Supplementary Report

Rum Jungle Rehabilitation Project – Environmental Impact Statement

NORTHERN TERRITORY GOVERNMENT

Document title	Supplementary Report
Contact details	Department of Primary Industry and Resources
Author	J. Hartnett
Date Issued	18/06/2020

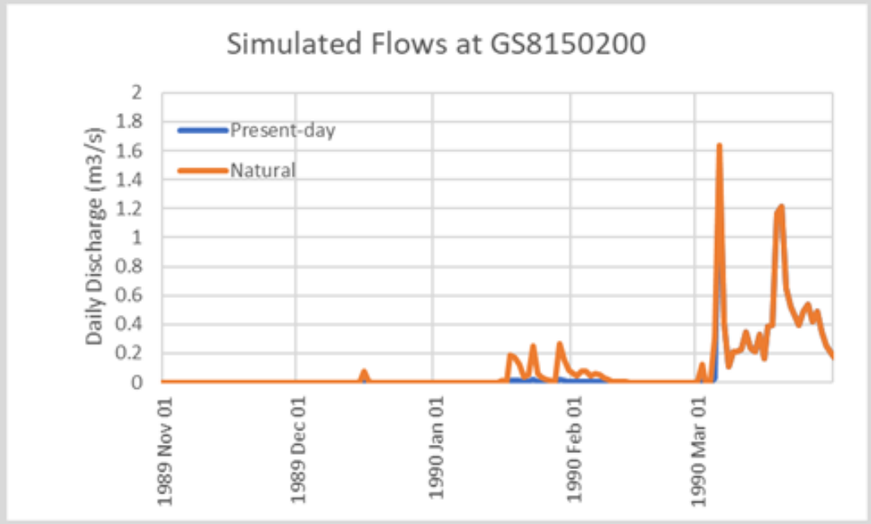
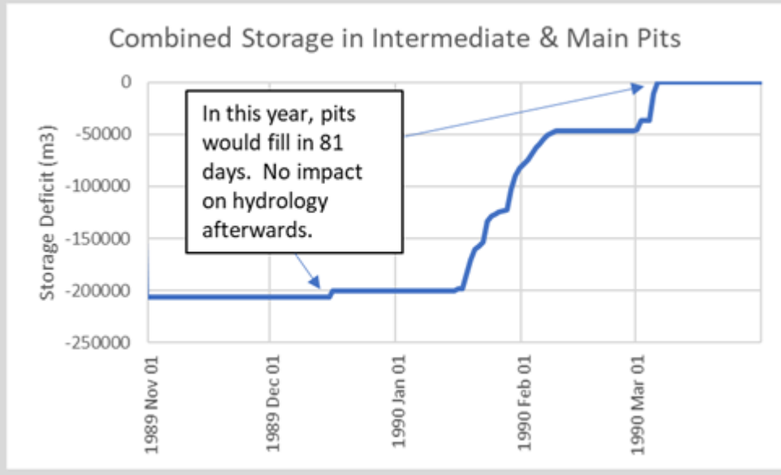
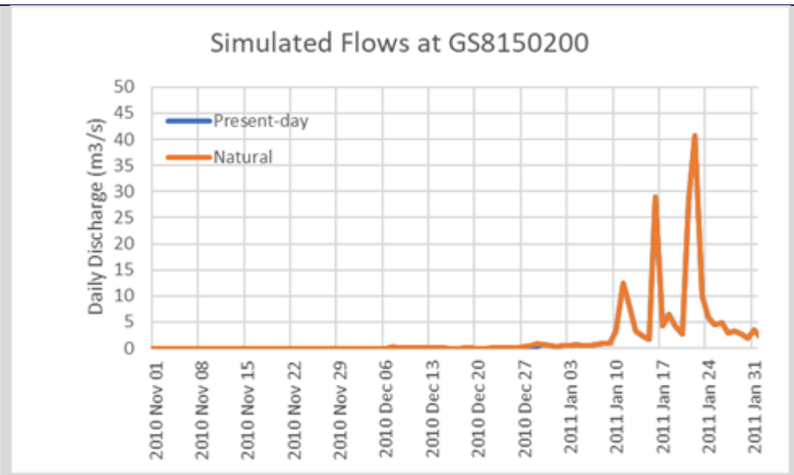
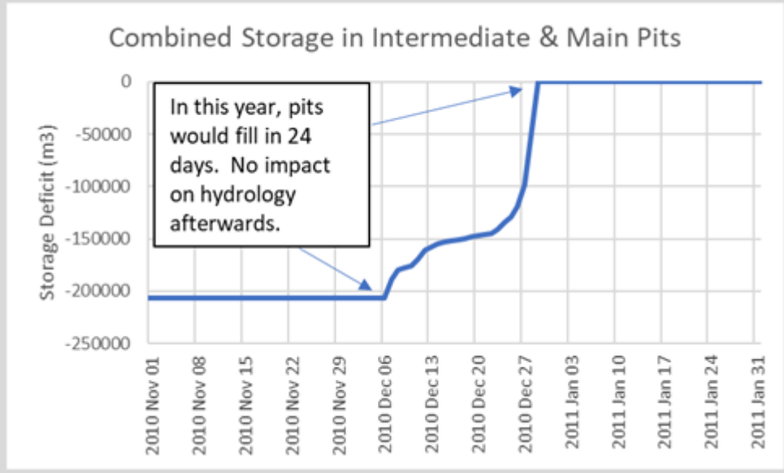
19	NT EPA	EBFR re-instalment of original flow path	11.3.1 Altered Surface Flow Regimes 7.7. Main pit backfilling	The re-instatement of the original flow path of the Finniss River is currently conceptual only. **Provide** a commitment to use appropriate standards and best practice for the design of the channel and include this commitment and details of standards in the updated Commitments Table.	See line item 34 in the Commitments table in Section 4. Additionally, the EBFR Diversion Design report by SLR is provided in Appendix 17.
20	NT EPA	Post-rehabilitation flows	11.3.1 Altered Surface Flow Regimes 7.7 Main Pit Backfilling	The Draft EIS states in section 11.3.1 "The reinstatement of the EBFR flow path will not significantly alter downstream hydrology. There may be a slight delay in 'wetting up' of this section of the watercourse as the Main and Intermediate Pit landforms fill to the point of overflow". Robertson GeoConsultants 2019 indicates that both pits experience substantial water losses in the dry season due to high evaporation and seepage rates, particularly the Intermediate Pit as it feeds directly into the porous Coomalie Dolostone. The Draft EIS indicates that the final Dry season water cover depth on the backfilled Main Pit will be determined by a hydrodynamic assessment to ensure that sufficient engineering controls are in place to reduce the risk of cap scouring and entrainment into the EBFR. The design of the Main Pit water cover is essential information for the NT EPA to determine acceptability of the cover. **Provide** the hydrodynamic assessment report, including assessment of final cover depth of the Main Pit, or a detailed plan for the development of such an assessment. The assessment should take into account impacts of climate change and aquatic weeds. Include worst case scenarios of climate change extremes for rainfall, evaporation and cyclones, as well as worst case scenarios of potential aquatic	SLR have verified the capping approach within the Main Pit as described in the EBFR Diversion Design report Appendix 17 by a process of: 1. Establishing estimated backfill settlement rate and profile to predict the pit lake bed profile. 2. Establishing the flow conditions over the cap during a 1% AEP flood event. 3. Establishing the material Particle Size Distribution. 4. Selecting an analogous critical velocity for saturated soil erosion. 5. Comparing the flow velocity with the critical velocity for erosion. 6. Estimating the sedimentation performance of the Main Pit as sediment trap. Further detail can be found within the Appendix report. The findings of this work indicate that the erosion and scour risk for the Main Pit clean cover is low, and that the pit lake is more likely to behave as a sediment trap for a long period of time. The report also finds that monitoring of downstream erosion and sedimentation processes would be required to determine if the reconstructed channel requires repair, maintenance and intervention to improve sediment replenishment processes impacted by the Main Pit lake. This has been included in the Draft Monitoring Plan provided in Appendix 1. Note also that pit lakes will be too deep to be choked with the aquatic weed species – Olive Hymenachne.

weed infestation of the pits (see Aquatic weeds - long-term integrity of landforms). **Quantify** the delay in surface water flows in the re-aligned EBFR due to filling up of both pits at the beginning of the wet season. Include, as a minimum, effects of average and low pit water levels at the start of the wet season for average and low rainfall years	At the end of the dry season, the pits require 206,000m^3 to cause overflow to the EBFR. The Intermediate Pit catchment is 45.6 km^2. For the driest year on record, the simulated flows at GS8150200 are:

To meet the storage deficit in the driest year, pits (Main then Intermediate) would fill in 81 days to then overtop:

For the wettest year on record, simulated flows at GS8150200 are:

Pit filling to overtop would take approximately 24 days:

Please note that the final decision making for full closure of the existing EBFR diversion channel is to take place in Stage 3 once performance of the main pit cap and revegetation system is established. At this time, data will be available to examine the EBFR flow delay and assess the impact of this, which is expected to be low.
21	NT EPA	Water balance	2.5.7 Water Management 10.6.1 Predictive Groundwater Modelling	The water balance provided for the project does not account for water demands during construction (dust suppression, drinking water, etc.). Robertson GeoConsultants 2019 reports that between 10 – 100 L/s of treated water is predicted to flow to the EBFR during the dry season. Section 2.5.7 of the Draft EIS provides estimates for potable water requirements and indicates that construction water for dust suppression and WSF lime mixing and placement would be sourced from the WTP (treated water) and possibly from Browns Oxide site. Section 10.6.1 indicates that construction water demands have not been accounted for in the Water and	See Section 3.13 Water Balance.

Figure 3-7 Borrow Area B riparian vegetation buffer

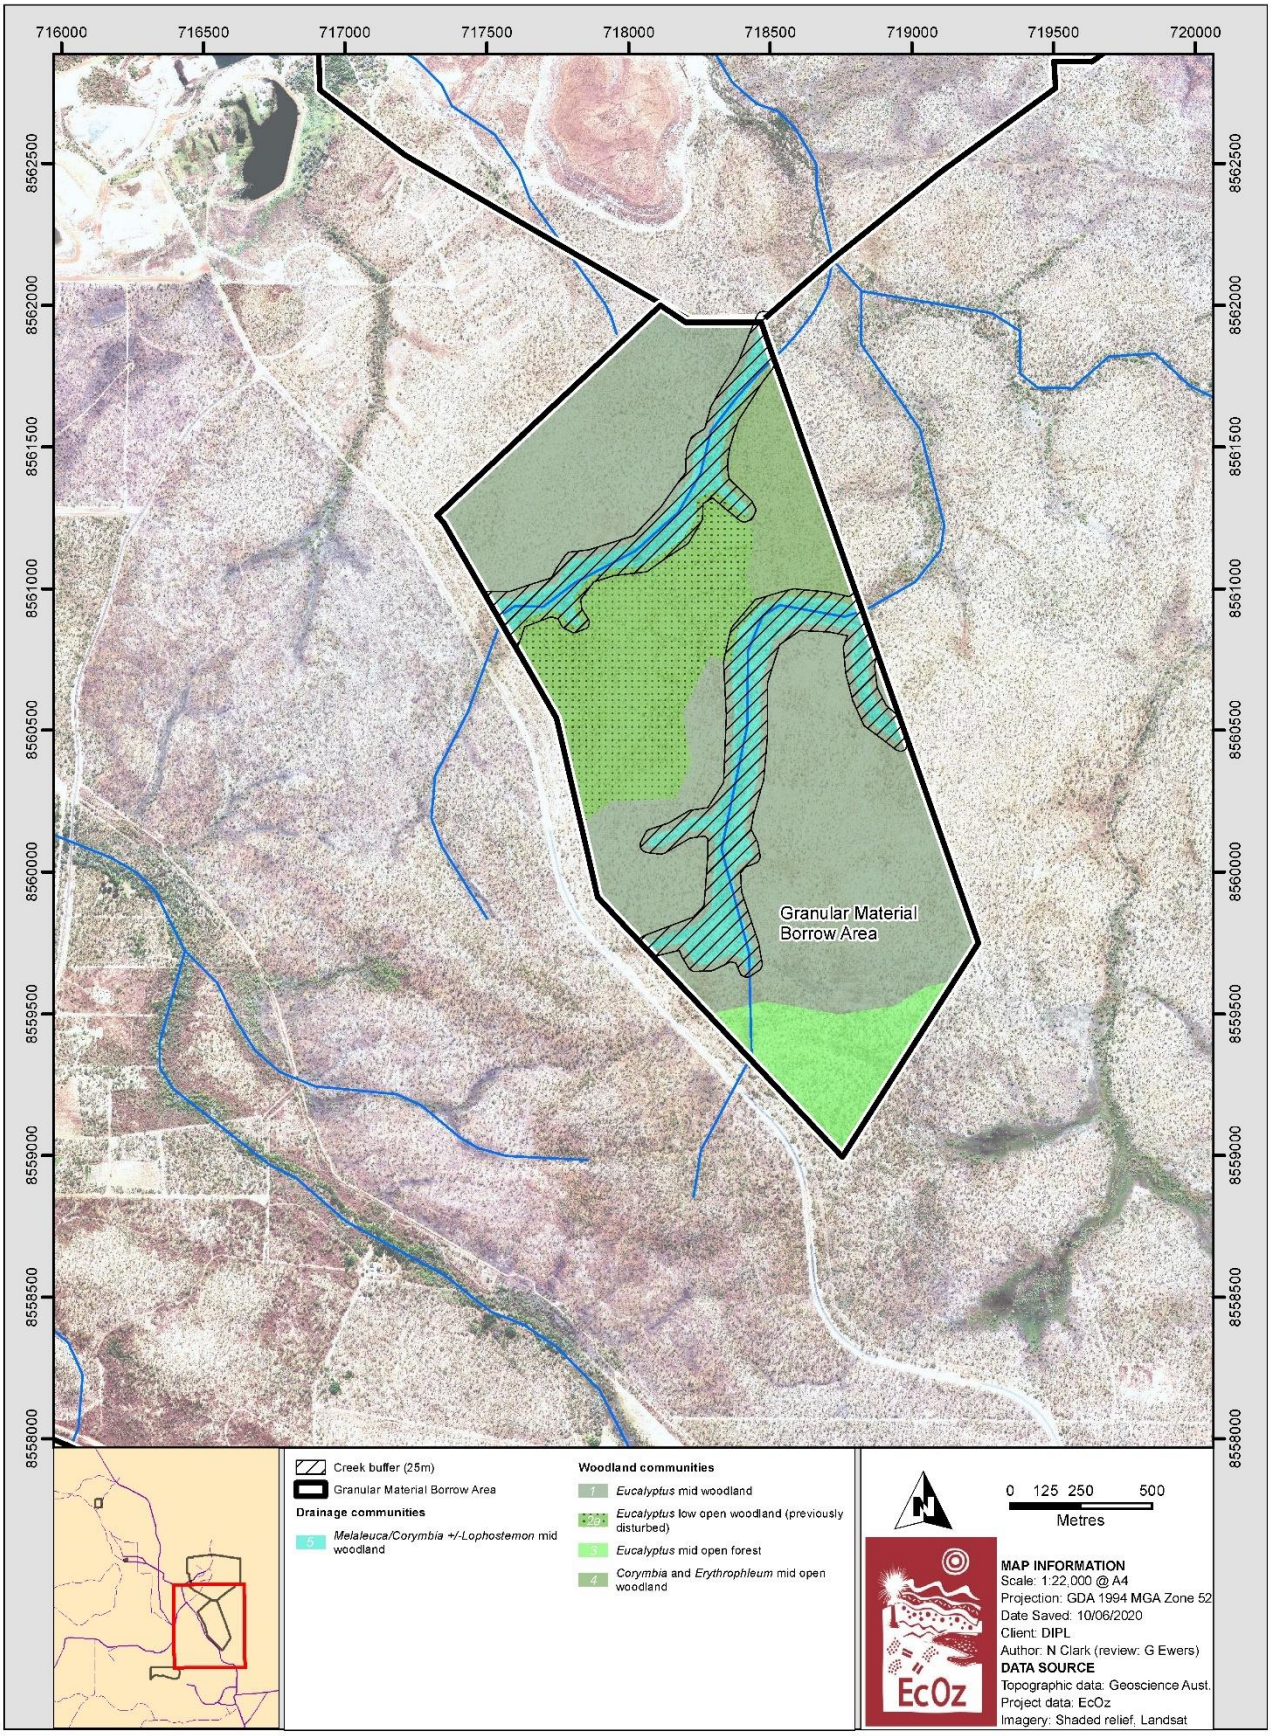
<table>
<tr>
<td></td>
<td></td>
<td></td>
<td></td>
<td>a protective buffer of native vegetation between the clearing area and the riparian vegetation.
Provide further information about the proposed clearing locations and environmental values in the Proposal area (Rum Jungle Mine Site, satellite sites, borrow areas), including:

The entire low permeability material borrow area is heavily-infested by Gamba Grass and was previously disturbed. Of the granular material borrow area, 19.9% has been previously disturbed – see Table below and Figure 3-7. The remaining woodland is intact, with only patchy weed infestations. Extraction of materials from that site will concentrate on previously-disturbed areas, with only 2 ha of remnant bushland having to be cleared.
Apart from the riparian vegetation mentioned above, the only other significant vegetation type that will be disturbed is a number of small patches of vine thicket (totalling 0.46 ha). That vine thicket is on the very eastern margins of the patch. No wetlands will be cleared.
Quantification of vegetation types to be cleared
<table>
<tr><th>Footprint</th><th>Broad vegetation type</th><th>Area (ha)</th><th>% total footprint</th><th>Remnant & not weed-dominated</th><th>% total footprint</th></tr>

Figure 3-14 Validated Geological Map

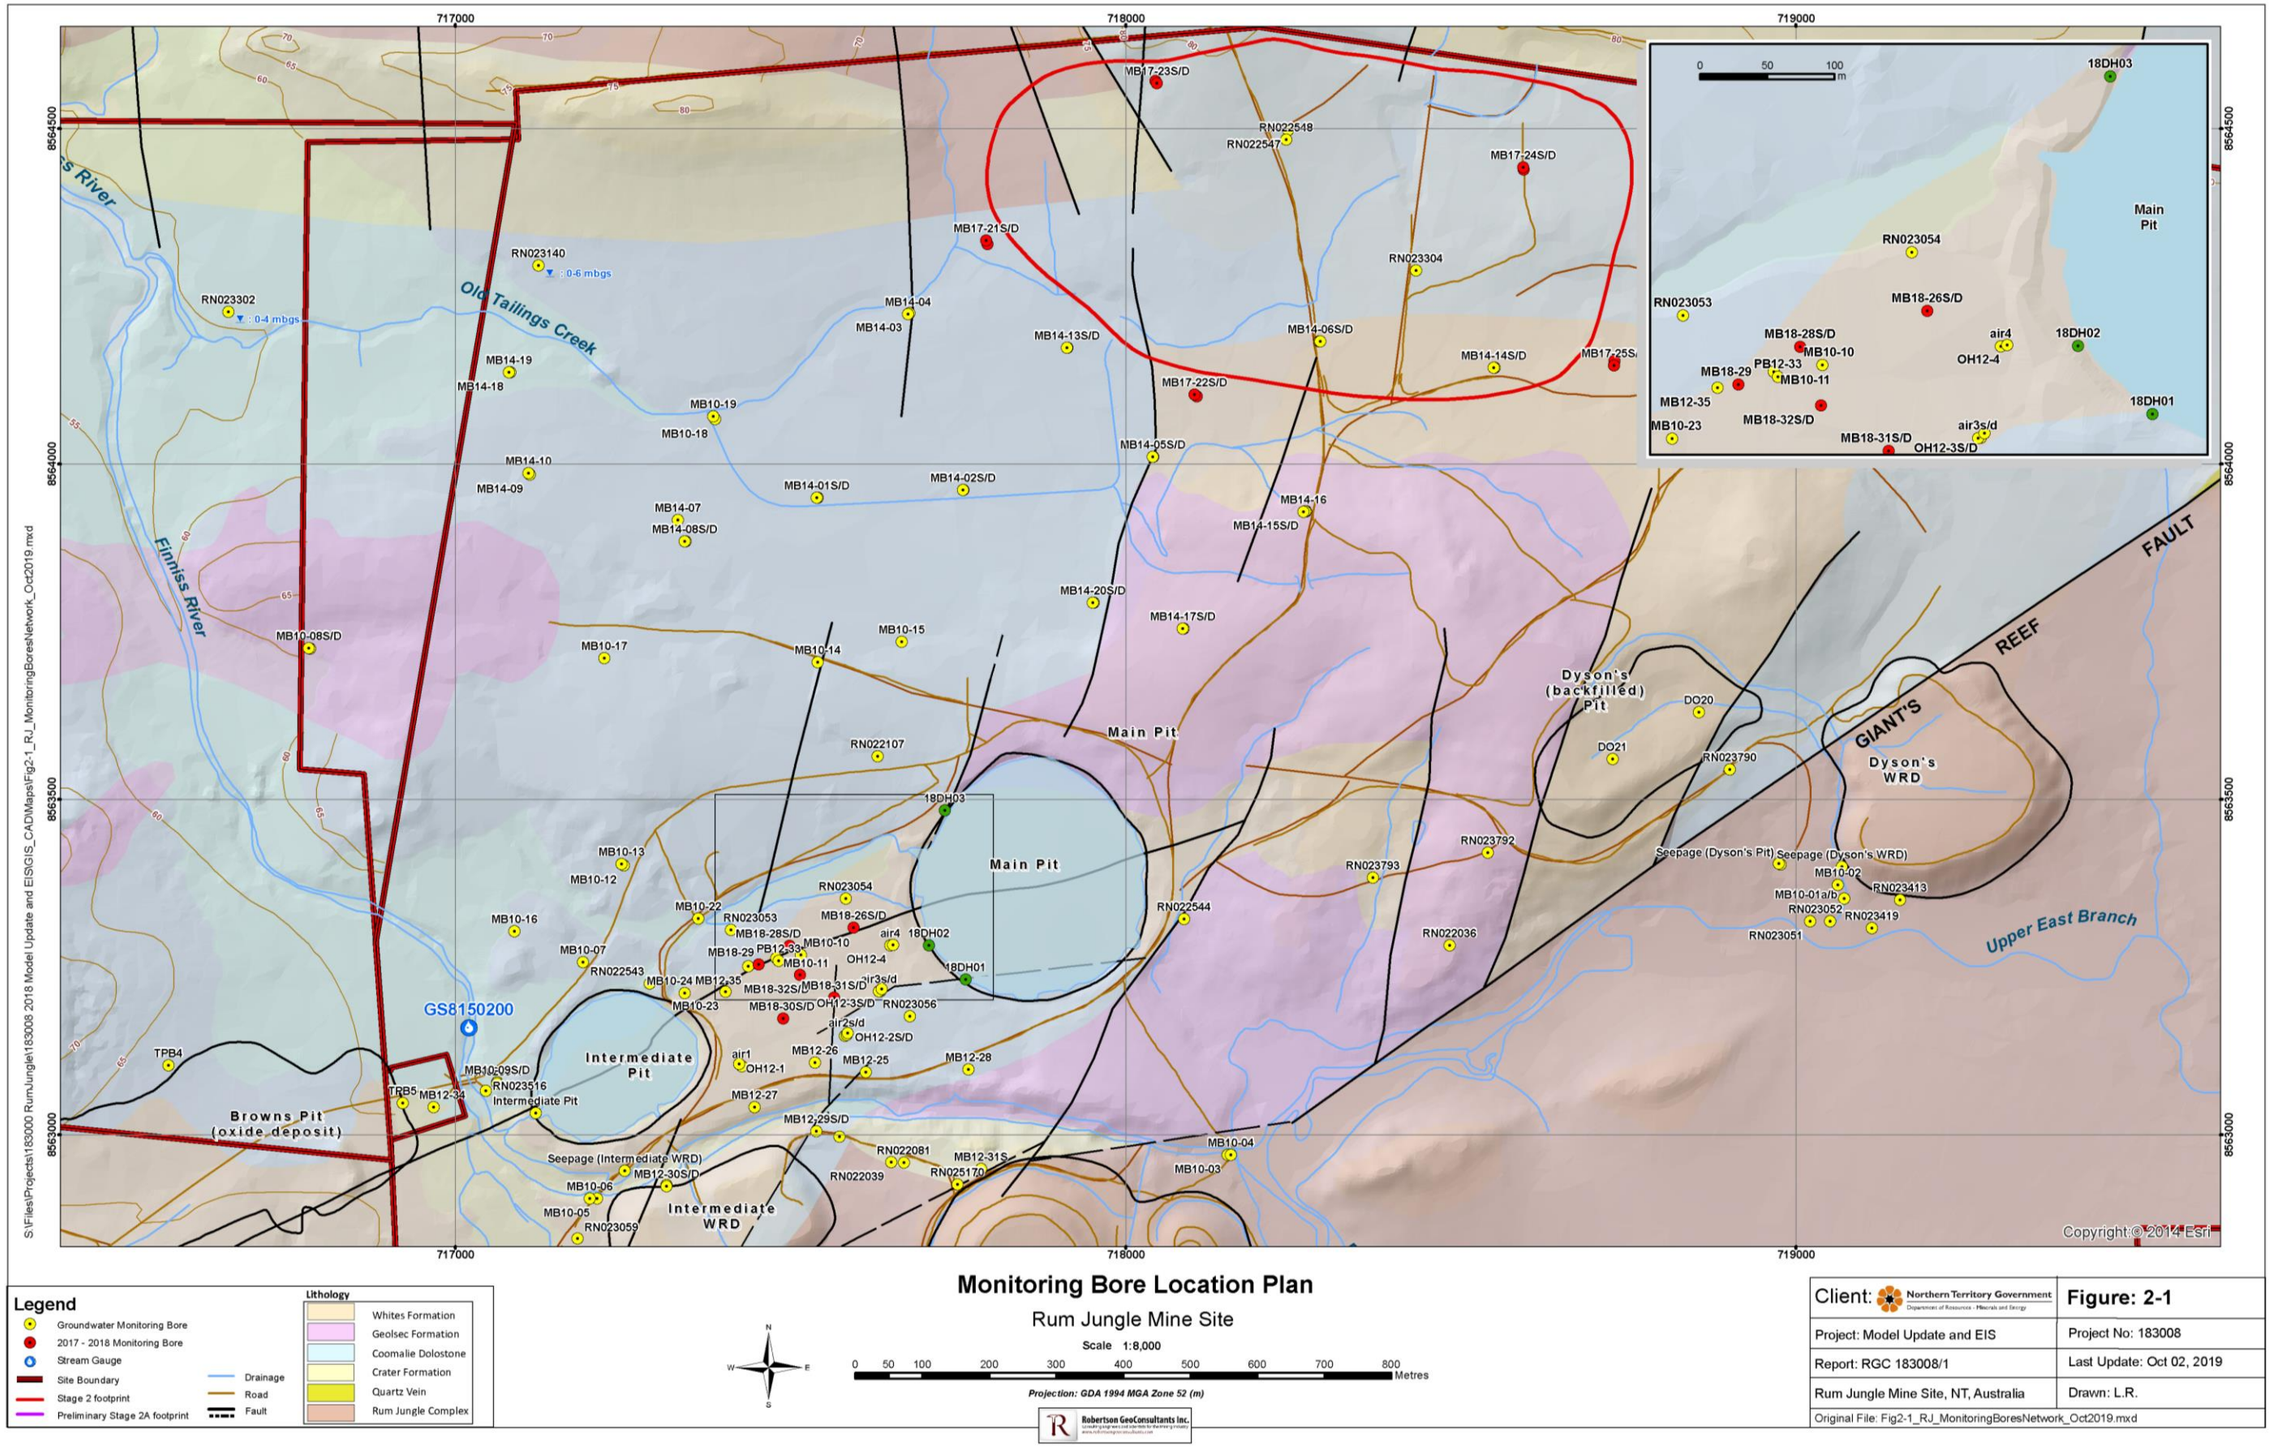
67	NLC	Table 10-2 & 10-3	10.4.1 P10-13	It would be useful to include conductivity into these tables.	Noted.
68	NLC	Acronym	10.4.1 P10-15	*Seepage directly to the EFDC* I assume this acronym is East Finniss Diversion Channel? This should be added to the abbreviation / acronym list.	Noted.
69	NLC	Further groundwater studies	10.4.1 P10-15	*Of interest are potentially high concentrations in deeper groundwater beneath the Intermediate WRD that may migrate northward beneath the EFDC towards Intermediate Pit based on the prevailing hydraulic gradients in this area. Additional monitoring bores and recovery bores (for pump testing) are warranted* It is very important to understand groundwater flow paths in order to develop the most appropriate remedial action. What is the proposed timing of additional pump testing and monitoring bores in order to ascertain any deeper flow paths. We assume this will be undertaken during the detailed design.	Pump testing will take place during the start-up of Stage 3 works to help inform the location of the Groundwater SIS bores, the location of which is described in the Draft Monitoring Plan (Appendix XX). Please see Figure 3-14 Validated Geological Map for current monitoring bore locations.

Figure 3-25 Comparison of Simulated and Observed Heads and Calibration Results

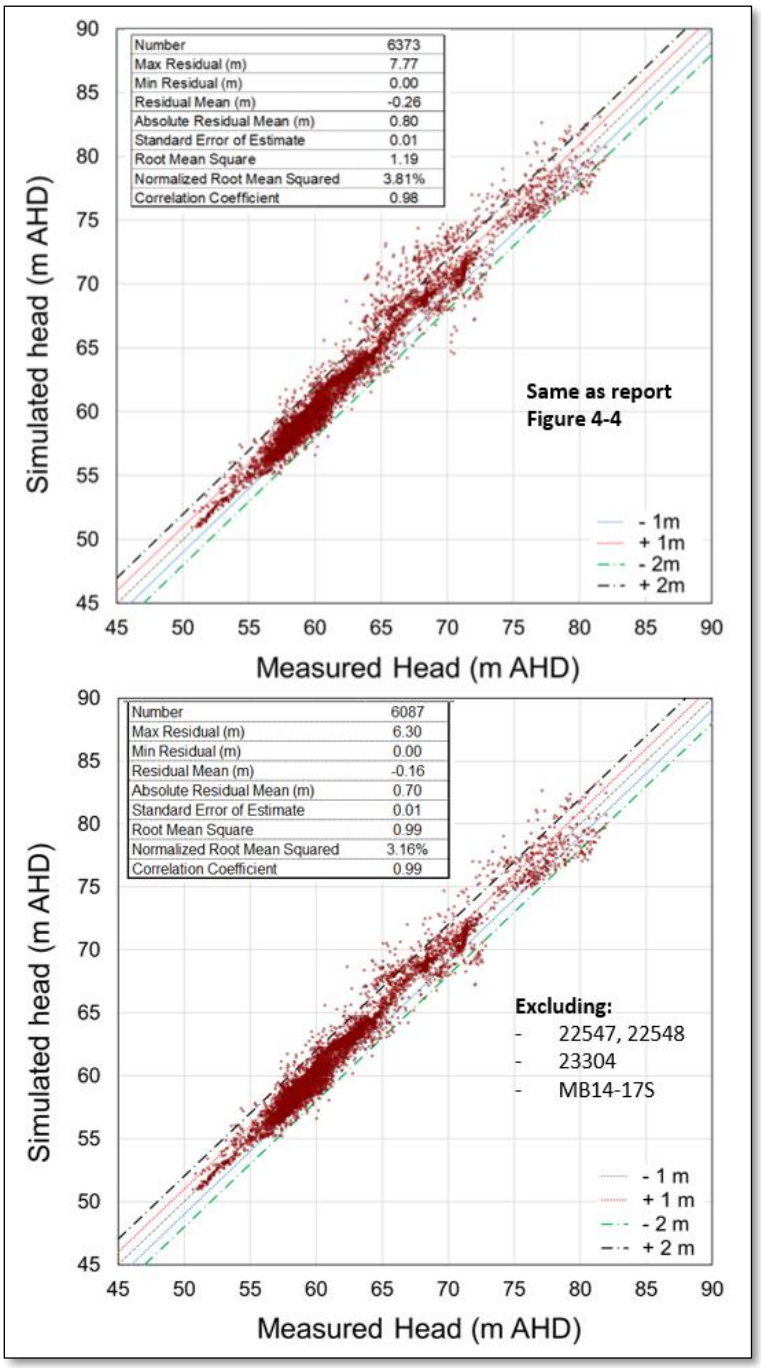
plume. The lithology map indicates this may put the plume in different geological formations. A bimodal pattern is noted in the calibration results of simulated versus observed heads (Figure 4-4). Below approximately 65 m AHD nearly all the results fit between +2 m variation. However, above 65 m the spread of data becomes much wider with many points showing a difference greater than +5 m. Given the majority of the data is for groundwater elevations below 65 m AHD this may be biasing the calibration statistics. <u>Sensitivity and uncertainty analysis</u> The Draft EIS provides a comparison between observed and modelled loads in the EBFR of Cu and SO_4. Observed and simulated loads differ up to 43% for SO_4 and up to 60% for Cu in a given water year. The results are considered a "reasonable" agreement by the author of the report, however the term "reasonable" is not defined further. The report states that the ranges of flow and transport parameters used in the sensitivity analysis are considered "plausible", however, a clear explanation of how ranges were derived is not given. Additional uncertainty analysis is recommended (e.g. as described in Middlemis and Peeters 2019). The report contains 14 recommendations to reduce model uncertainties but no indication was given in the Draft EIS if these will be implemented. <u>Model Assumptions</u> **Provide** justification for the use of the selected single dispersivity values to represent dispersivity for heterogeneous geological formations. <u>Differences between observed and modelled current conditions</u> **Provide** clarification of differences between observed and modelled current conditions, including: • an explanation for the discrepancy in plume locations and whether this may have implications for the predicted contaminant transport. • an explanation of the bimodality in the calibration data as well as separate calibration statistics above and below 65 m AHD. <u>Sensitivity and uncertainty analysis</u> **Provide** • an explanation for the choice of parameter ranges used in sensitivity analyses

With respect to the bimodal distribution in water levels, most of the spread in water levels on the scatter plot (above 65 m AHD and greater than 2 m) is caused by local discrepancies between bores RN022547 and RN022548 (which are 15 m apart) and bores RN023304 and MB14-17S. Figure 3-25 compares simulated and observed heads with these bores included and excluding these bores, as requested. Calibration statistics showed a significant improvement (NRMSE dropped from 3.8 to 3.2) if the bores mentioned above are excluded.

The simulated heads by the calibrated flow model match the seasonal variations observed at these bores reasonably well (Figure 3-26). However, observed discrepancies, particularly at the highest and lowest values, suggest local aquifer heterogeneity and/or variability in response to local stresses such as evapotranspiration which are not accounted for in the model. These small differences for these four wells (and hence the bimodality in heads) is not a significant source of uncertainty in the model, so Robertson GeoConsultants did not exclude them from the model calibration.

Figure 3-25 below shows (top) all monitoring wells included in the data which is the same as Figure4-4 from Robertson GeoConsultants (2019) report provided with the Draft EIS. The bottom figure is for all wells with RN022547, RN22548, RN23304 and MB14-17S excluded.
